Cronus

Release

Notes

Cronus Hardware Release Notes

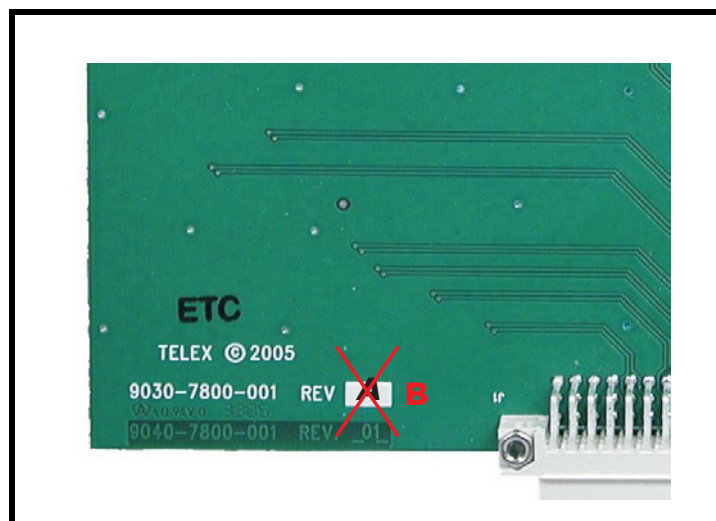
When a new Cronus AIO front card requires the use of a new Cronus AIO rear card (9030-7787-001) or Cronus MDR rear card (9030-7800-001). It will not work with the old board -000 rear card because signals are rerouted to eliminate the Party Line noise.

FIGURE 1. Wire Placement on the Cronus Front Card

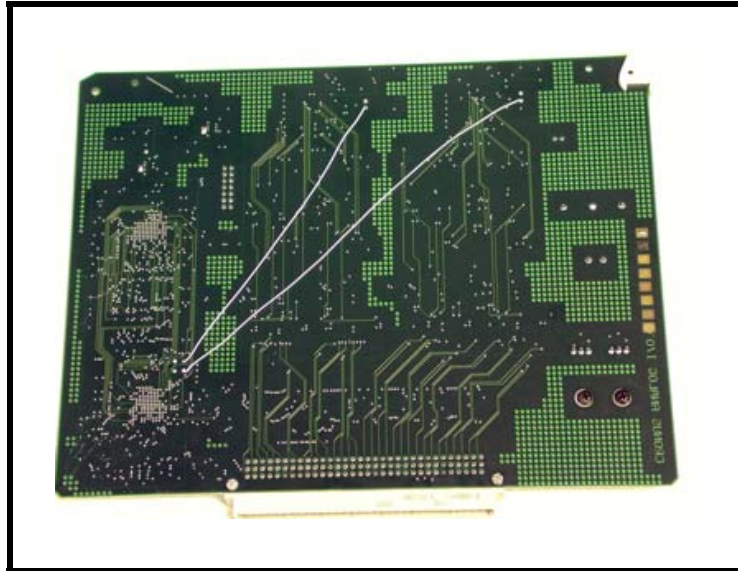
If you currently have the old Cronus AIO board and need to fix the audio distortion from the CODECs being asynchronous, do the following:

1. Identify test points TP4, TP18, TP19, and TP28 on the front side of the board.
2. Turn the board over to the backside.
3. Using Kynar type jumper wire, connect TP4 to TP18 and TP28 to TP19.
4. Turn the board over to the front side.

5. Using an ohm meter, check for continuity between TP4 and TP18 and continuity between TP28 and TP19.

FIGURE 2. Resistors and capacitors that need to change to upgrade the gain amount.

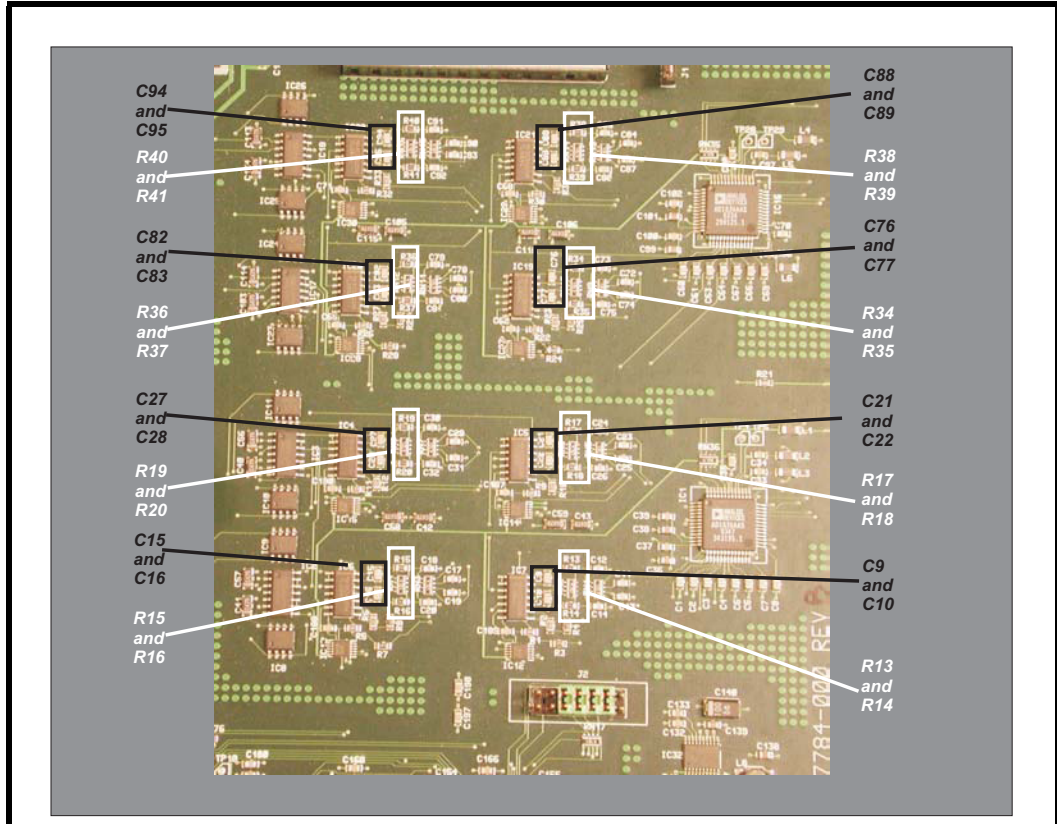
To Upgrade the Gain Structure yourself, do the following:

1. On the front card, replace the following 16 resistors with a 220k resistor (part number 102506-224)

R13, R14, R15, R16, R17, R18, R19, R20, R34, R35, R36, R37, R38, R39, R40, R41

3. On the front card, replace the following 16 capacitors with 12pF capacitor (part number 723411-14). See figure 2.

C9, C10, C15, C16, C21, C22, C27, C28, C76, C77, C82, C83, C88, C89, C94, C95.

FIGURE 3. TP7 Ground to J3 C1 connector placement

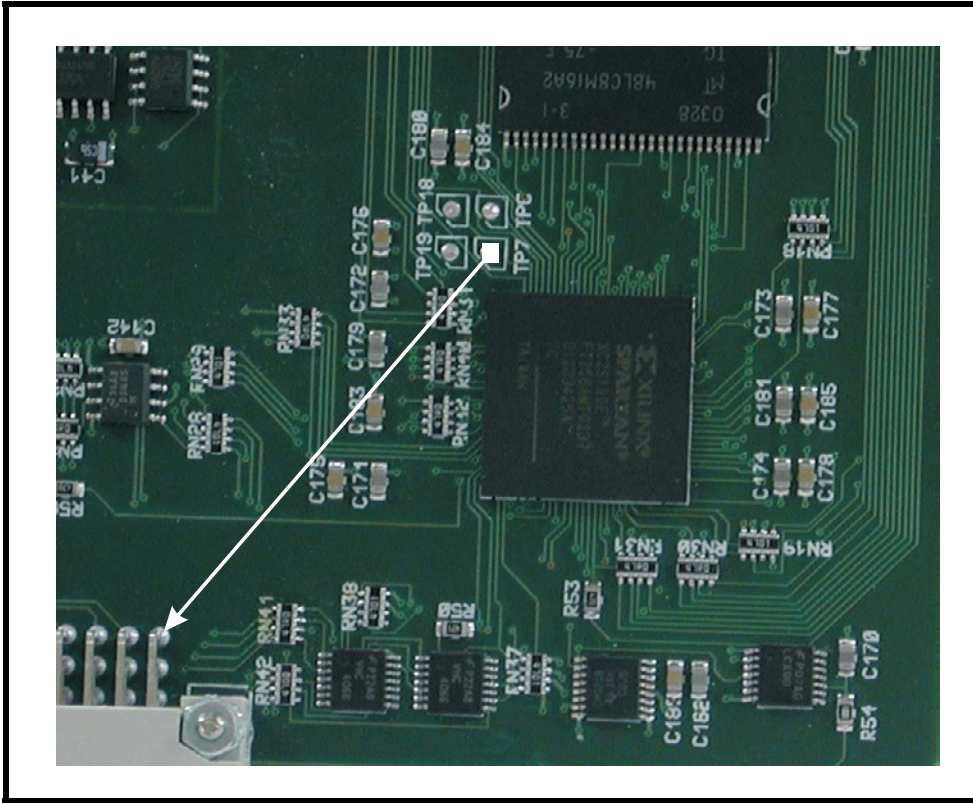
2. On the front card, ground TP7 to connector J3 pin C1 so it will be recognized as the new Rev D card. See figure 3.

FIGURE 4. New AIO board capacitor placement

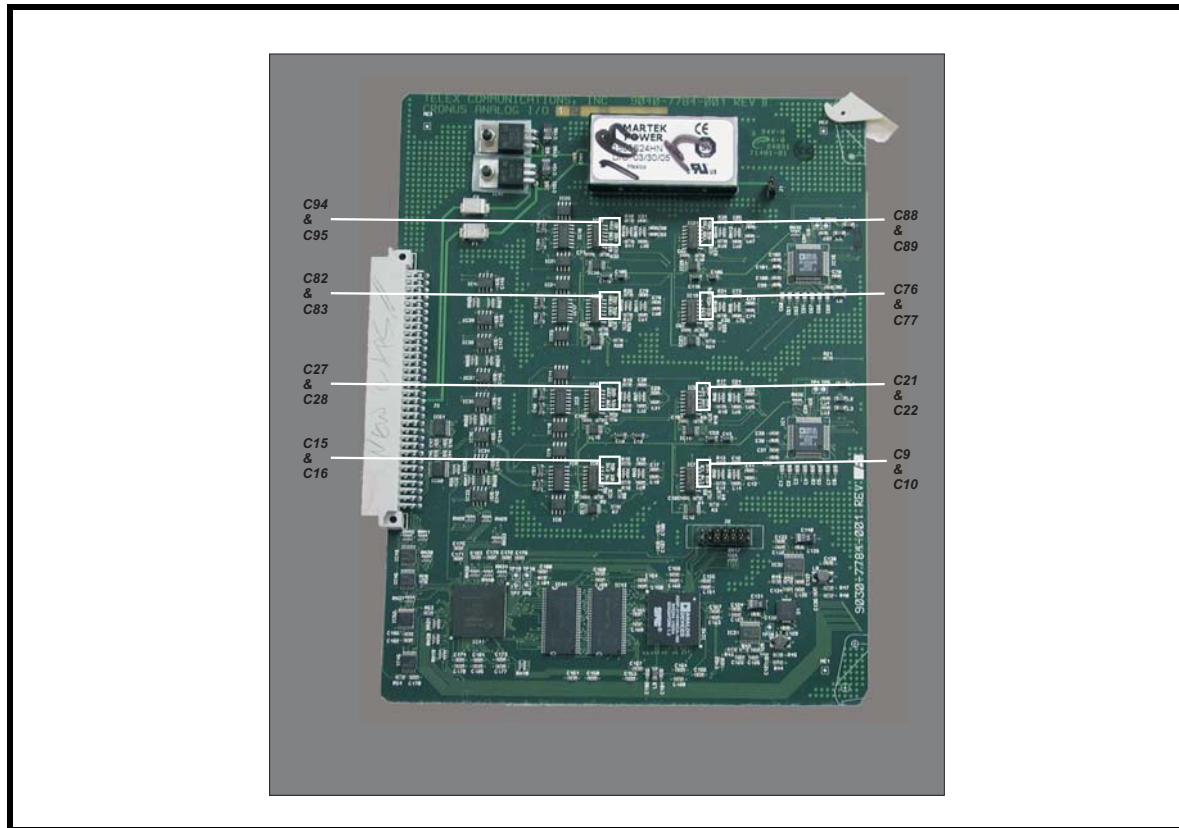
It was noticed that the frequency response starts dropping at 10KHz instead of 20KHz as specified in the User Manual.

To fix the Frequency Response problem, an EC #13-000341 was issued to replace 16 capacitors from 100pF to 12pF (part number 723411-14)

The 16 affected parts are C9, C10, C15, C16, C21, C22, C27, C28, C76, C77, C82, C83, C88, C89, C94 and C95.

The modified AIO front card should have the reference markup changed from 9030-7787-001 Rev B to Rev C. See figure 4.

FIGURE 5. Capacitors on the RJ 12 (A) rear card and the MDR (B) rear card.

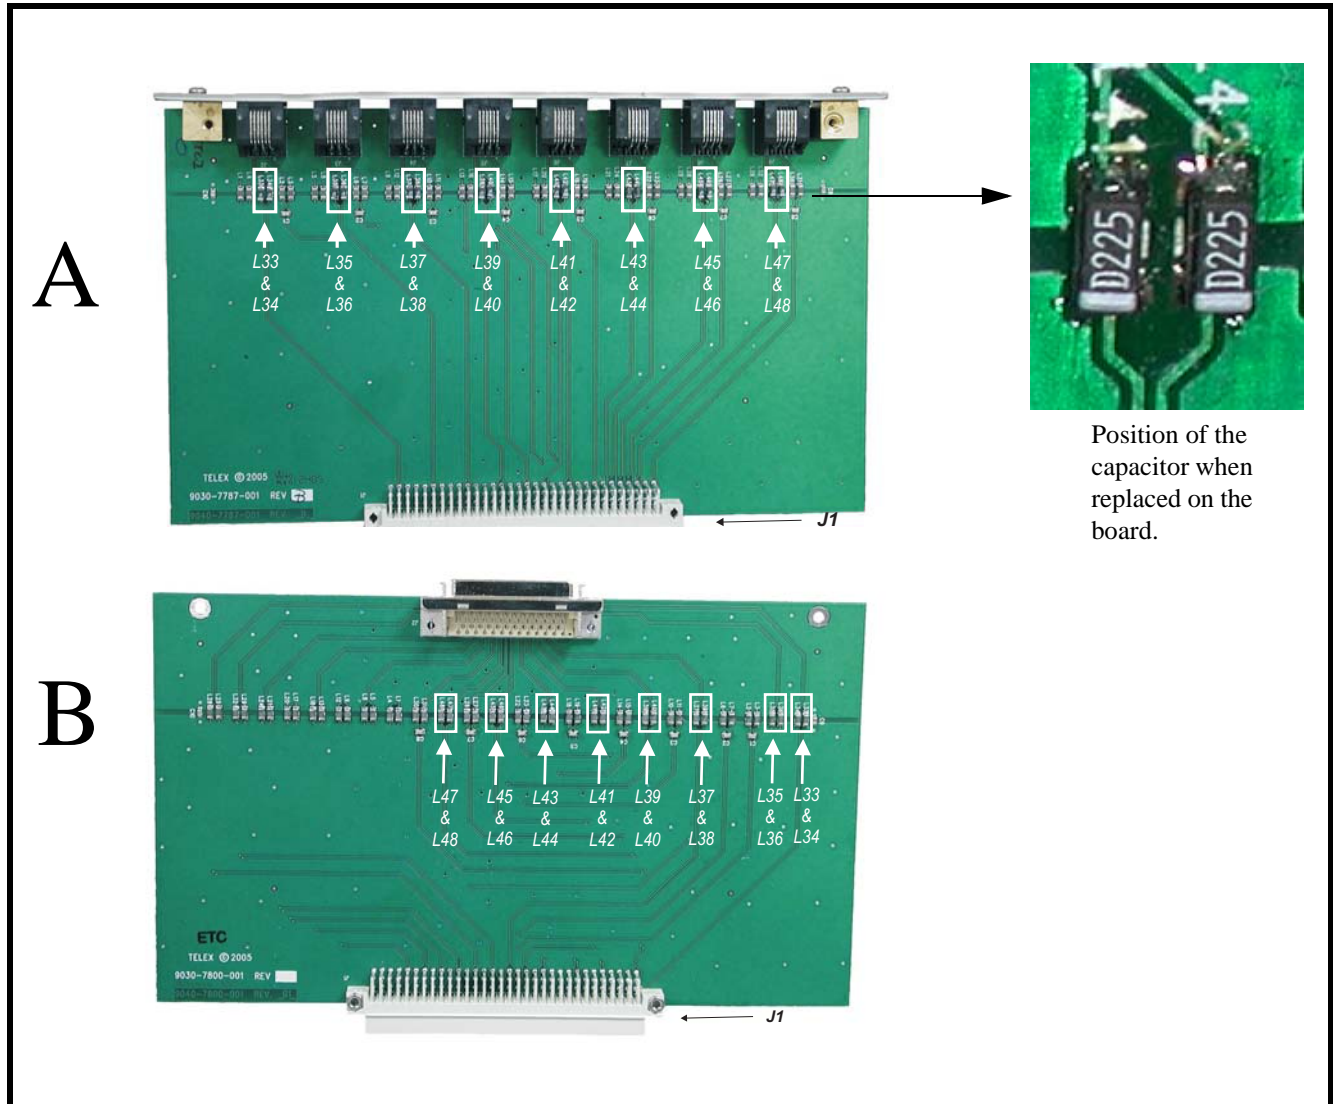
After changing the design to have an option for analog output gain up to +20dB, the AIO card (9030-7784-001) has exhibited DC bias voltage on the audio output differential pairs of +/- 1.8V.

To fix the DC Bias problem, two ECs were issued to replace the ferrite beads on the audio outputs of the AIO rear cards with DC blocking caps (4.7 uF/16V), part number 102877-070.

EC 46-000351 changes the RJ12 AIO rear card from 9030-7787-001 Rev B to Rev C (See reference A below).

EC 46-000361 changes the MDR Rear Card from 9030-7800-001 Rev A to Rev B (See reference B below).

The 16 affected parts are L33, L34, L35, L36, L37, L38, L39, L40, L41, L42, L43, L44, L45, L46, L47, L48.

IMPORTANT: The positive end of the capacitor should point toward J1 connector (see inset of figure above).

FIGURE 6. Resistor Changes on RVON-I/O (9030-7772-000)

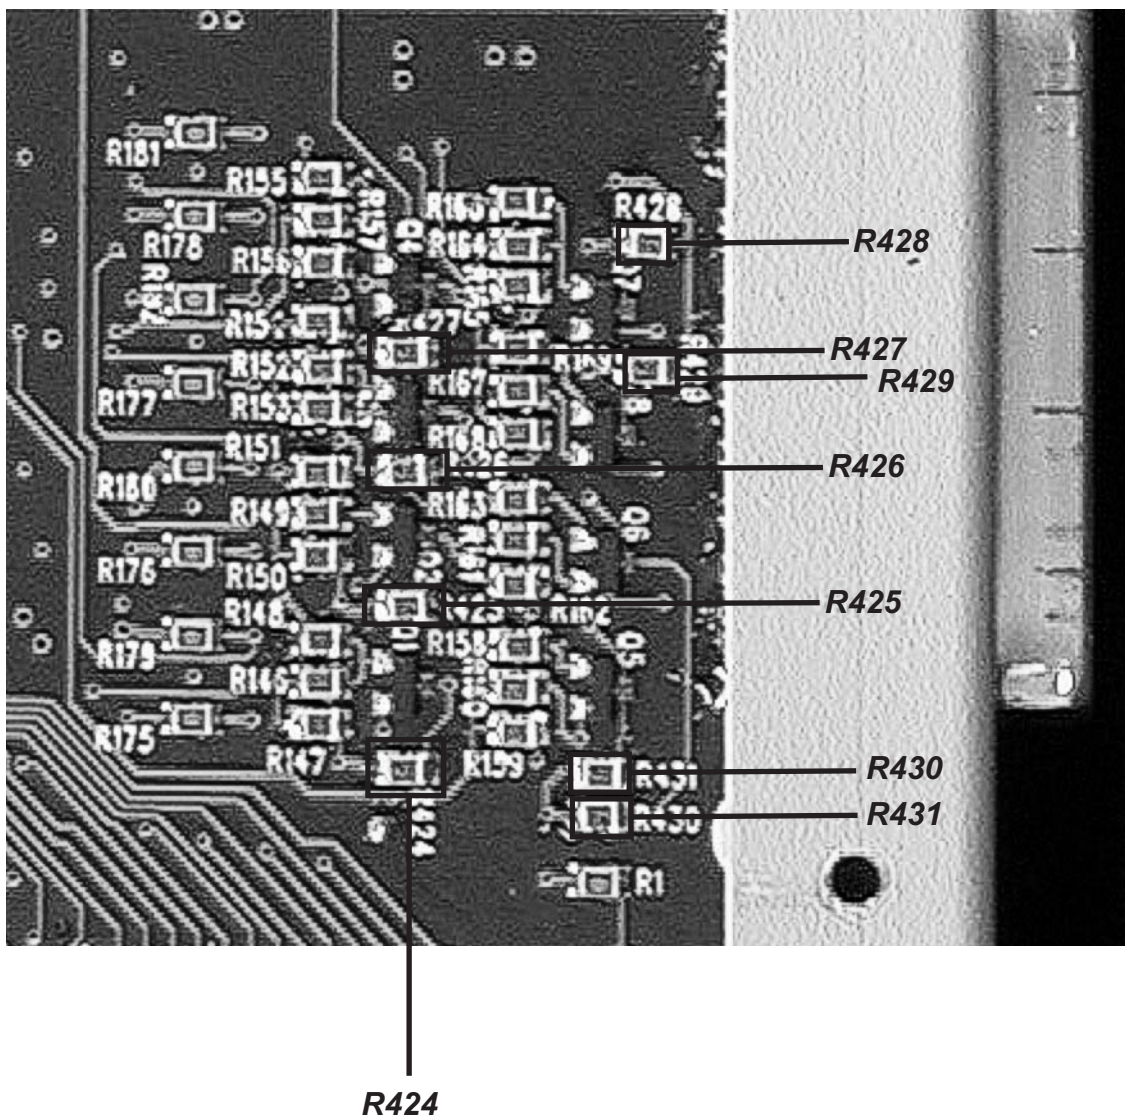
The RVON-I/O's voltage drop across the GPO Output resistor is too large for the Cronus photo coupler GPI. The Cronus series resistor to the photo-coupler is also too large. The voltage drops across both resistors prohibit operation.

To fix this issue, change the RVON-I/O GPO Output from 22.1K to 6.19K on the RVON-I/O card and replace four resistors (R11 through R14) from 3 K to 470 Ohms.

1. On the RVON-I/O card remove **8 resistors (R24 through R431)** and replace with **6.19 K resistors (part number 102515-276)**. See Figure 1 for resistor placement.

FIGURE 7. Cronus board resistor placement (9030-7788-001)

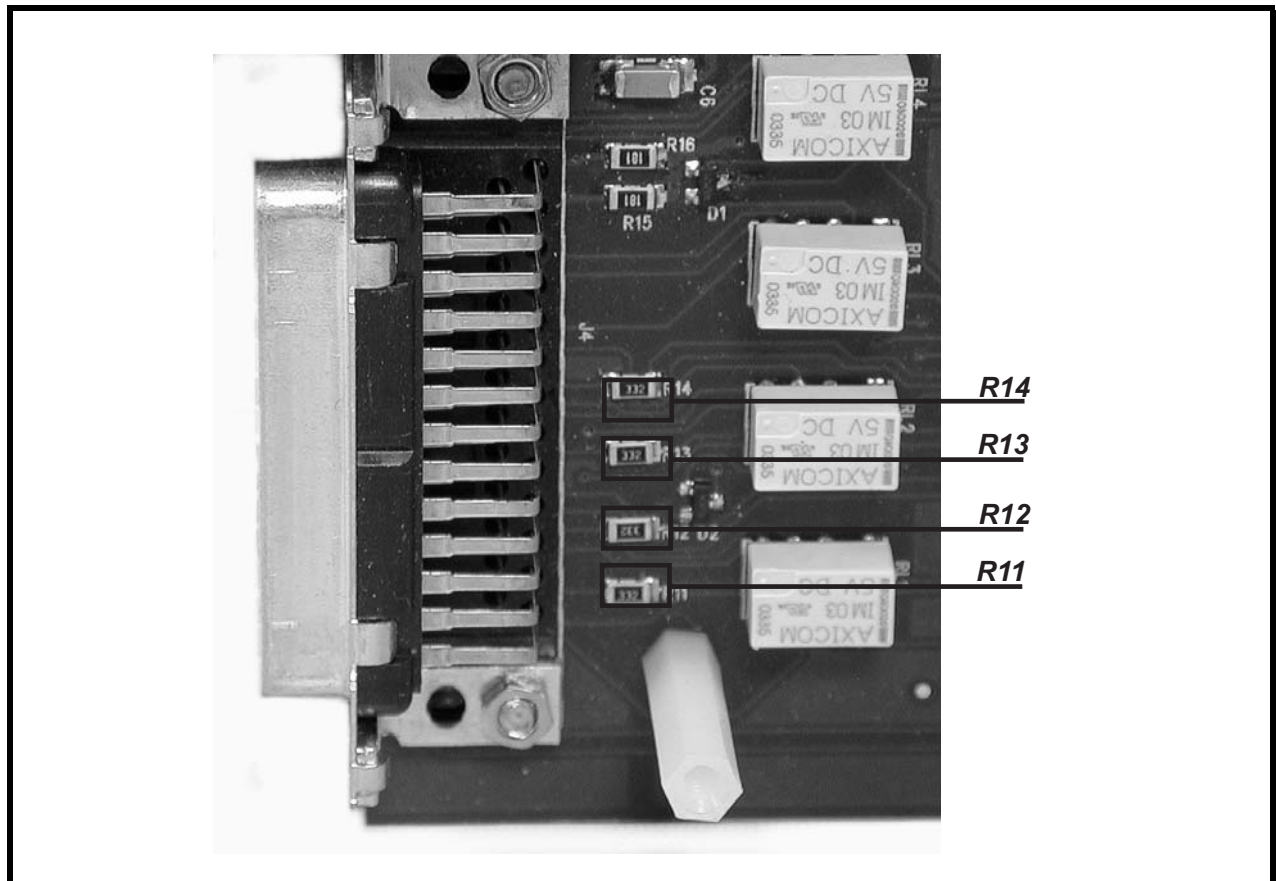
NOTE: The Cronus Master Controller backcard will go from **9030-7788-001 Rev A** to **9030-7788-001 Rev B**.

2. On the Cronus MC Back card, remove the **3K resistors (R11 through R14)**.
3. Replace the resistors with 470 Ohm resistors (part number 102513-471).
